RE: **Avery & Birch – Preliminary Approval**
21055 Crossroads Circle BKFT1129999007

Application Type: Preliminary approval of a new building consisting of a three-story salon suite facility

CONSTRUCTION PLANS
FOR
AVERY & BIRCH
21055 CROSSROADS CIRCLE
TOWN OF BROOKFIELD, WISCONSIN

Strand Associates, Inc.[®] (Strand) has finished its initial review of the plan package for the Avery and Birch Development that was received from the Town on December 28, 2023, for conformance with the Town specifications and general engineering practices. Before construction may begin, the contractor shall submit all required permits for the development to the state, Wisconsin Department of Natural Resources, Town, and any other relevant agencies. New drawings and a letter describing the revisions should be returned to Strand after the following concerns have been addressed.

SHEET NUMBER
C100

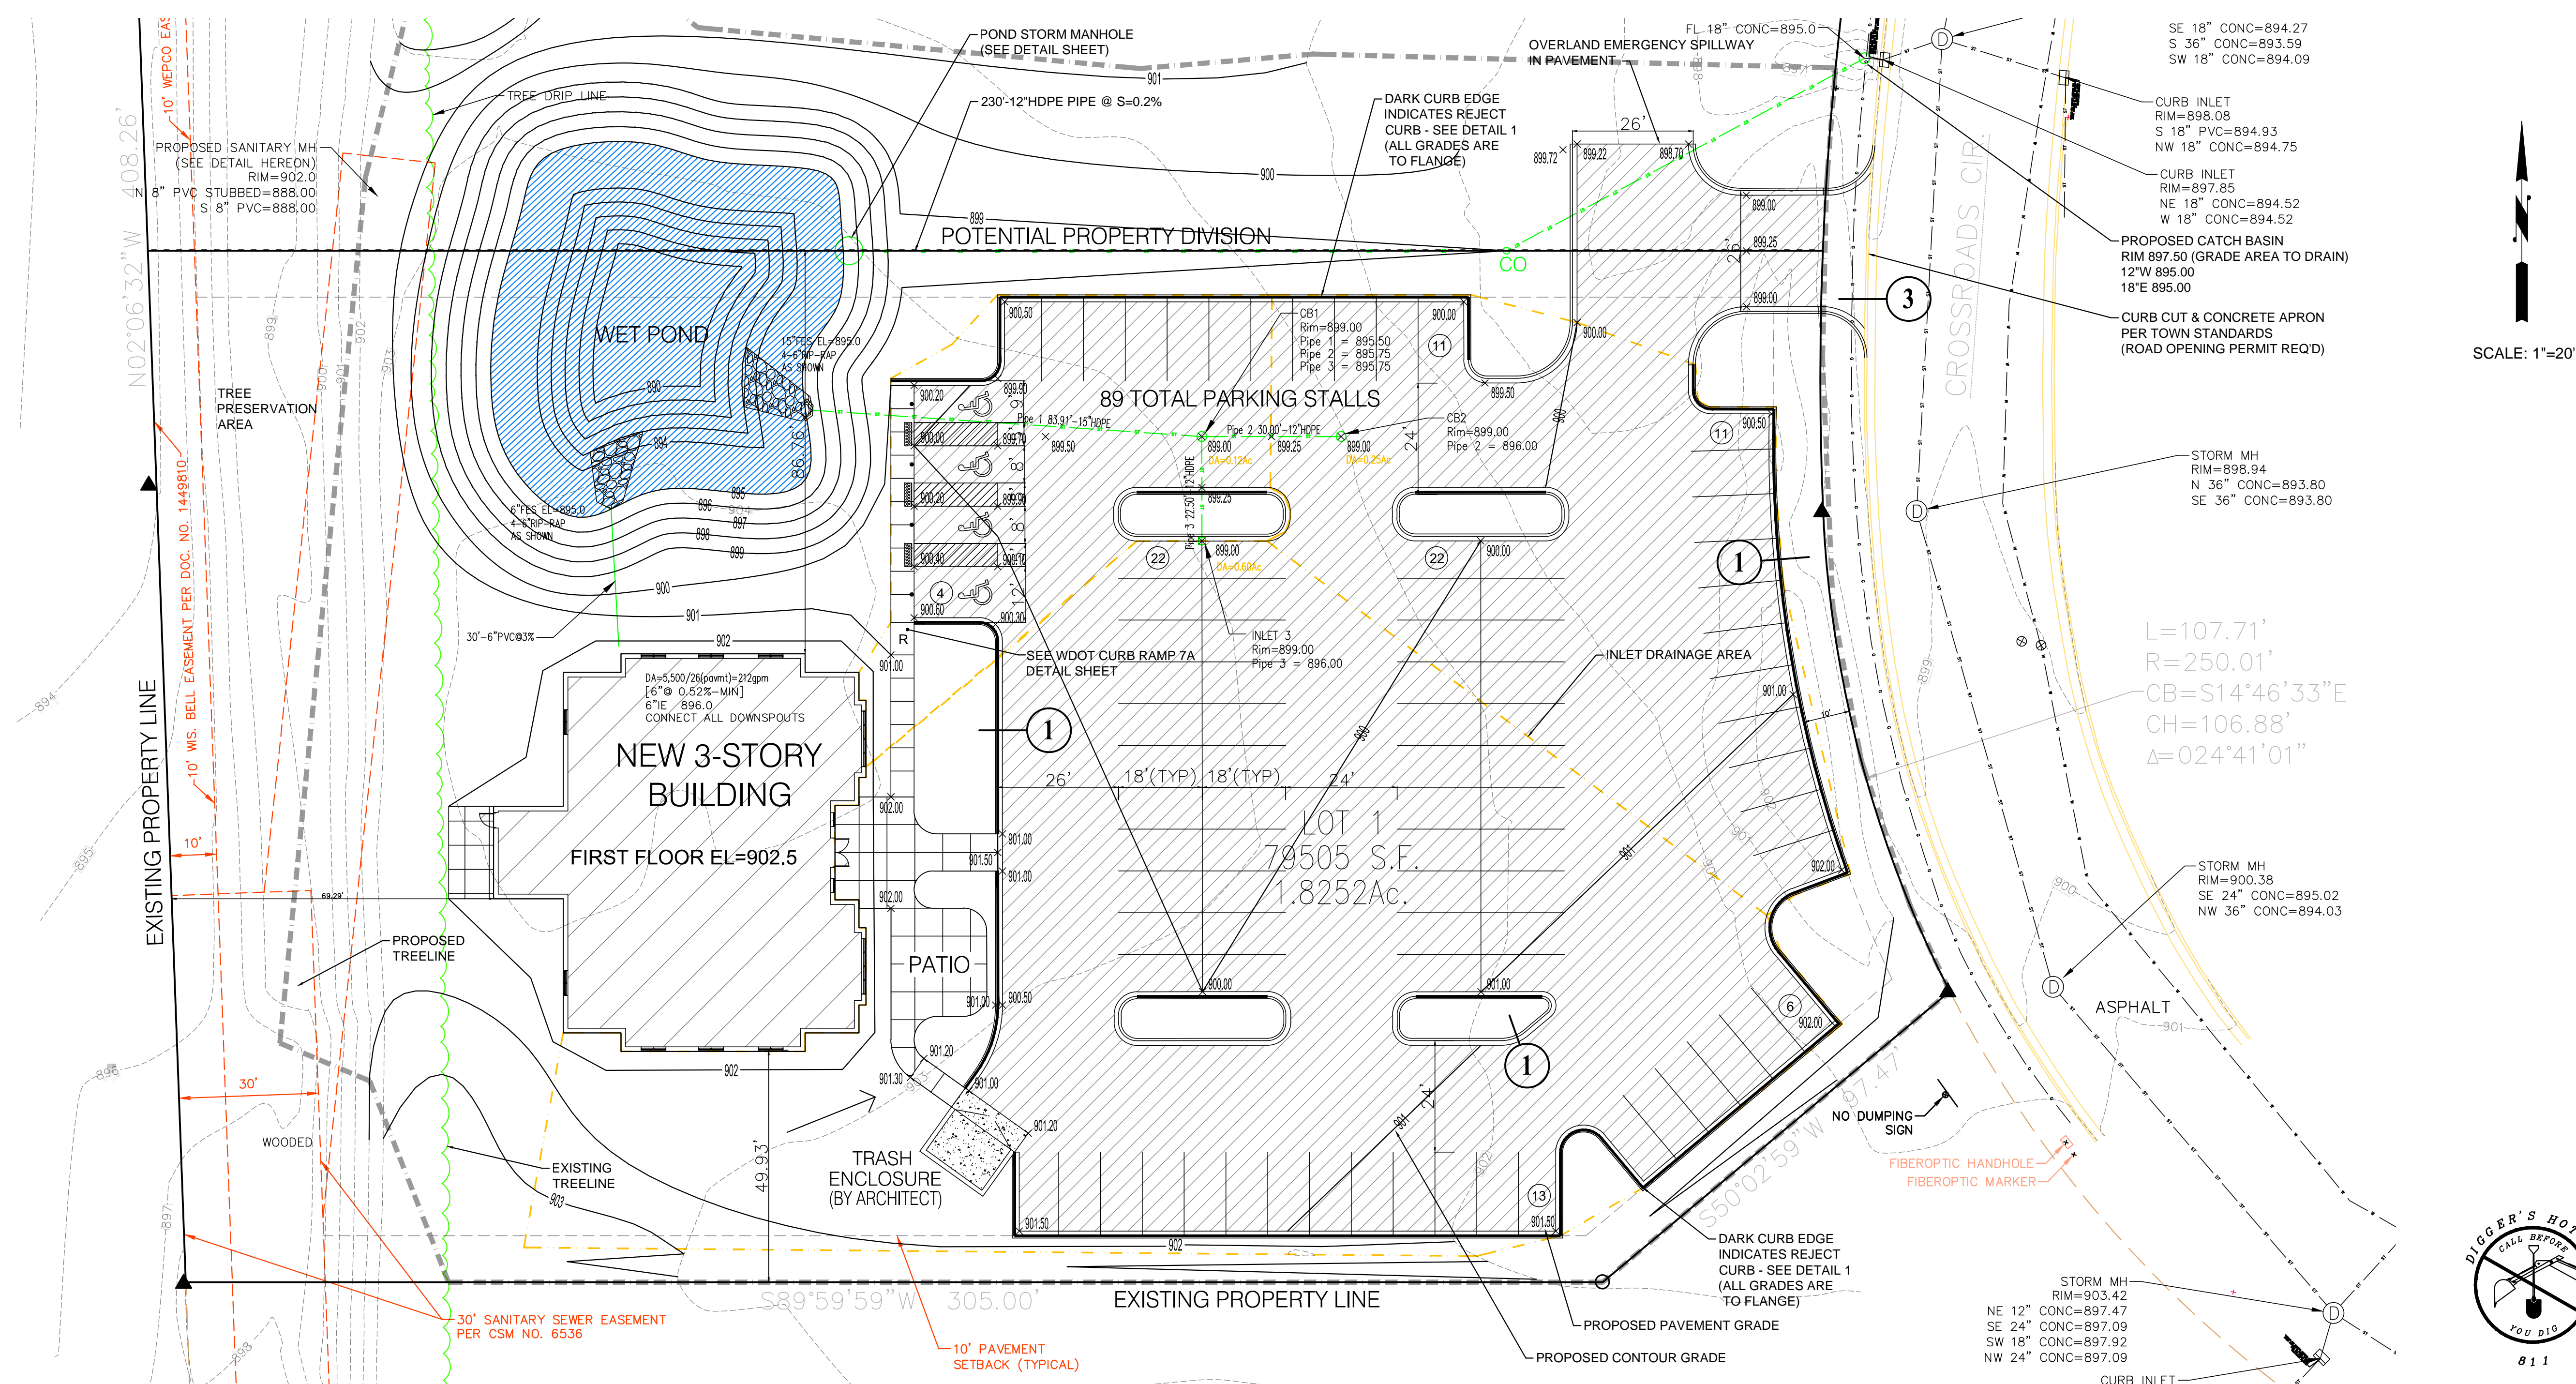
- The applicant is proposing to add a stormwater pond to the north of the building and this is proposed to serve the potential northern lot as well.
- Note: Some of the site data provided on the site plan (Sheet C100) is inaccurate as the total floor area and the floor area ratio.

1. According to Section 17.06(3)(c)(2) of the Town Zoning Code, 2 percent of the total number of spaces shall be designated for the physically disabled. The 2010 Americans with Disabilities Act (ADA) Standards, Section 208.2, requires a minimum number of physically disabled accessible parking spaces based on the total number of parking spaces provided in the parking facility. The Town should provide direction on which standard will be enforced. There are 89 parking stalls being provided, with two stalls (2.2 percent) being ADA-accessible. The 2010 ADA standards note that a minimum of four ADA compliant stalls shall be provided if the total number of stalls ranges from 76 to 100.

3. A turning moving exhibit should be provided to verify the largest vehicle (including any emergency vehicles) that will access the site can perform the required turning movements with the proposed layout.

MARK R. ELLENA
 E-24090
 WALES, WI
 PROFESSIONAL ENGINEER
 DATE: 01-17-24
 BY: MARK R. ELLENA, PE
 SCALE: 1"=20'
SHEET NUMBER
C200

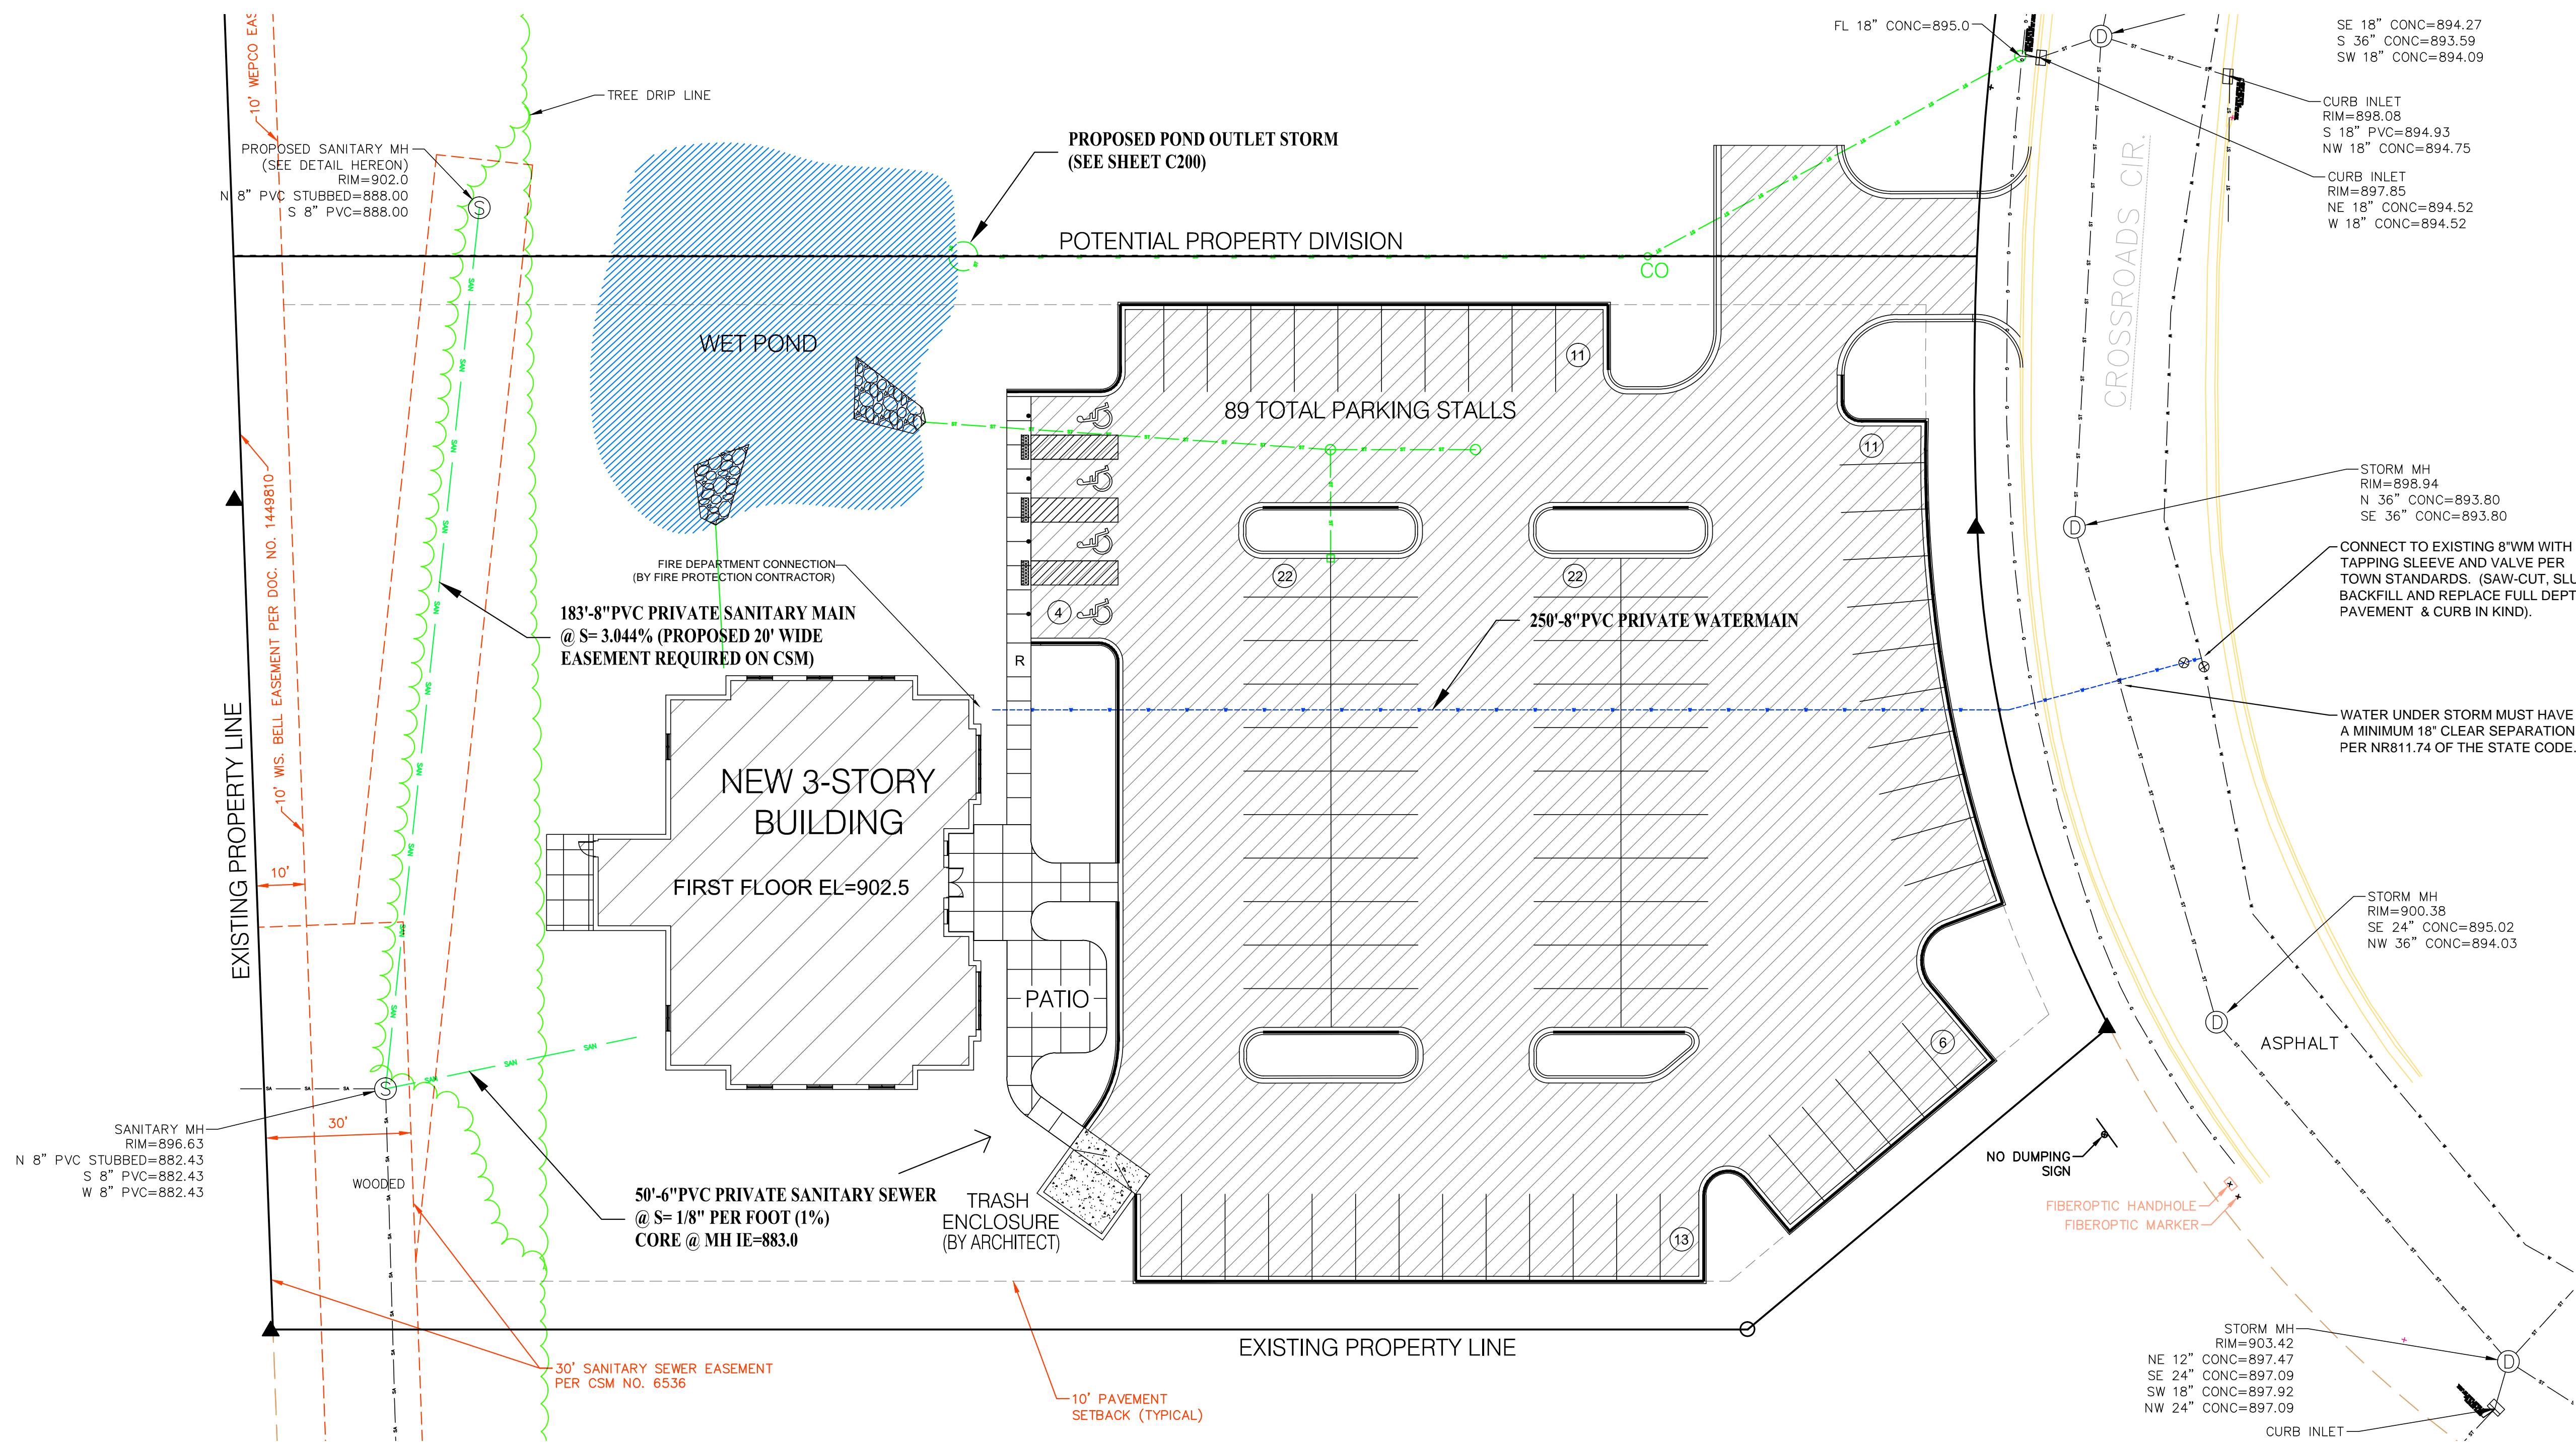
2. There is a callout stating “Concrete Curb & Gutter (see detail), reject curb along exterior of lot.” The detail on the sheet is of standard curb and there is no detail for the reject curb. It is not clear what exact curb type is used at what locations (i.e., whether all islands contain regular curb). More detail should be added to the construction drawings identifying the different curb types.

3. A more detailed grading plan is needed for the handicap-accessible route in order to determine whether the proposed grades are ADA-compliant. Also, dimensions should be included for the handicap-accessible parking stalls and access aisle.
